FIRST ADDENDUM TO DEVELOPMENT AGREEMENT

Case No(s). H-2024-0043

Newkirk East MDA, PP

A Preliminary Plat and Development Agreement Modification to convert 216 apartments into 95 single-family attached homes on 10.08 acres of land zoned Traditional Neighborhood Residential (TN-R).

D. Preliminary Plat (date: 7/3/2024)

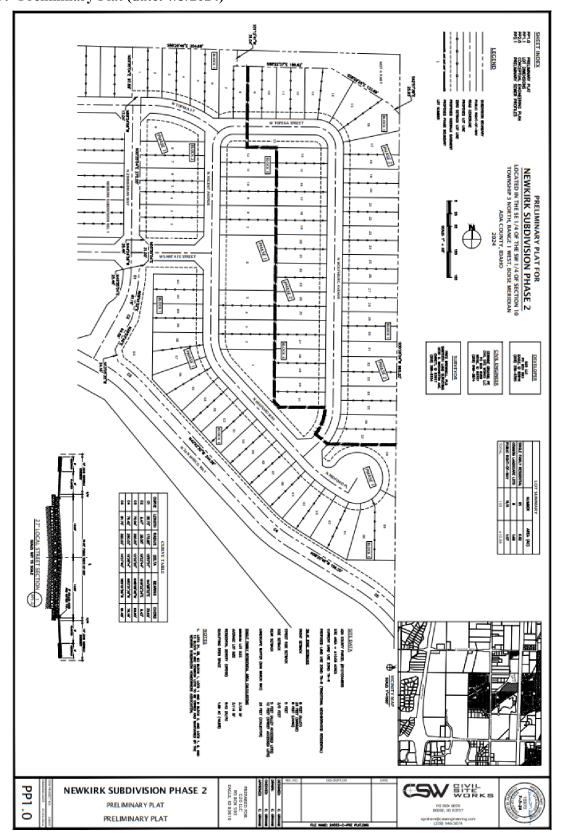
The proposed dead-end street is approximately 569 feet and requires City Council waiver. The applicant is required to provide a pedestrian connection from the street to an adjacent existing or planned pedestrian facility. The applicant shall revise their plat map to show how they meet the requirements or provide justification as to why they cannot meet the requirement. The applicant has the option of providing an open space tract within the lots along N. San Marco Way to break up the length of the dead-end road.

The applicant's narrative states that there are five (5) single-family attached three-plex, two-story alley-loaded garage homes. However, the preliminary plat does not depict an alley to accommodate these alley-loaded garages. The applicant must revise the plat map to clearly indicate the location of these homes and the corresponding alleys. Additionally, all alleys must comply with the requirements set forth in the Unified Development Code (UDC).

Lots 2-8 front both N. Ascent Avenue and N. Zimmerman Way. The applicant shall revise the plat map to remove the double street frontage which is prohibited per UDC 11-6C-3. The applicant needs to add a ten (10) foot landscape buffer along the west side of the lots to eliminate the double frontage and access to the parcels will be from N. Ascent Avenue.

Revise the plat map to bring the dead-end street into compliance per UDC 11-6C-3B-4 by adding a pedestrian facility along N. Midford Way (Lot 46 or 47, Block 1) to the open space area along N. San Marco Way located within Lot 63, Block 1.

- Revise the plat map as Lots 2-8, Block 2 have double street frontage which is prohibited per UDC 11-6C-3. Add a ten (10) foot landscape buffer along the west side of the lots to eliminate the double frontage and access to the parcels will be from N. Ascent Avenue.

- Revise the plat map to bring the block length along A. Wolfsburg Avenue into compliance by adding a pedestrian facility along Block 3, in the vicinity of lots 20-23 to connect to the common lot on Lot 3, Block 3.

- Revise the plat map to bring the dead-end street into compliance per UDC 11-6C-3B-4 by adding a pedestrian facility along N. Midford Way (Lot 46 or 47, Block 1) to the open space area along N. San Marco Way located within Lot 63, Block 1.

E. Landscape Plan (date: 7/3/2024)

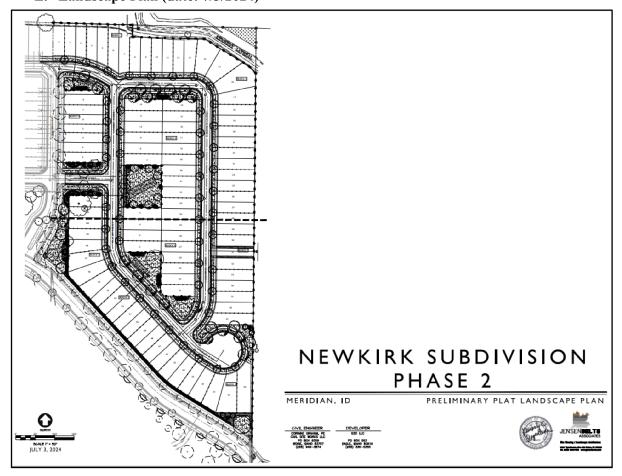
Per the UDC the minimum width of parkways planted with Class II trees shall be eight (8) feet. The width can be measured from the back of curb where there is no likely expansion of the street section within the right-of-way; the parkway width shall exclude the width of the sidewalk. Class II trees are the preferred parkway trees. The applicant will be required to revise their landscape plan to show Class II trees.

I. Block Length Exhibit (date: 7/3/2024)

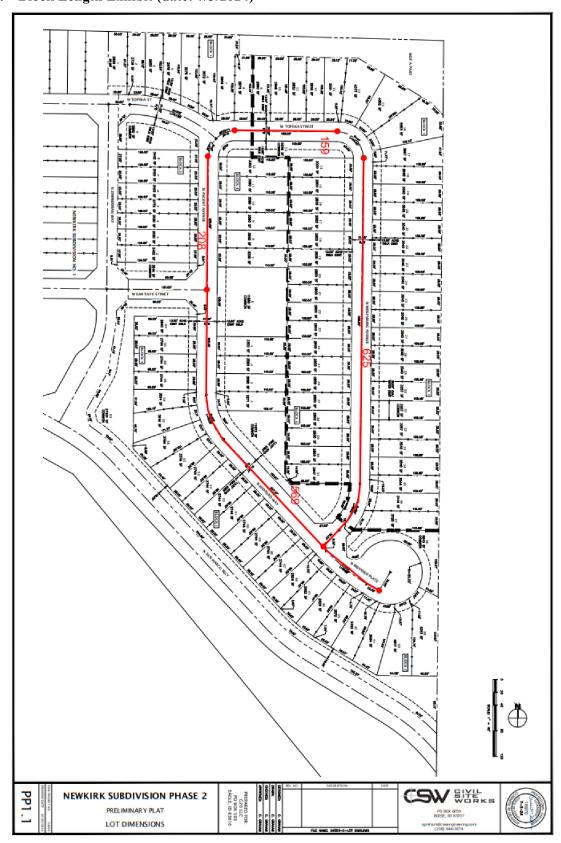
The applicant has several blocks lengths that exceed the 500 feet which need to be shorten or justification needs to be provided as to why they cannot meet the requirement. The applicant has provided an emergency access to N. Manship Lane within the Entrata Farms Subdivision No. 2, which counts towards a break in the block length on the east side of the roadway. The applicant can provide access to the open space area along N. Ascent Avenue from N. Wolfsburg Avenue to break up the block length on the west side of the road. Revise the plat map to bring the block length along A. Wolfsburg Avenue into compliance by adding a pedestrian facility along Block 3, in the vicinity of lots 20-23 to connect to the common lot on Lot 3, Block 3.

- 4. Add a pedestrian facility along Block 3, in the vicinity of lots 20-23 to connect to the common lot on Lot 3, Block 3.
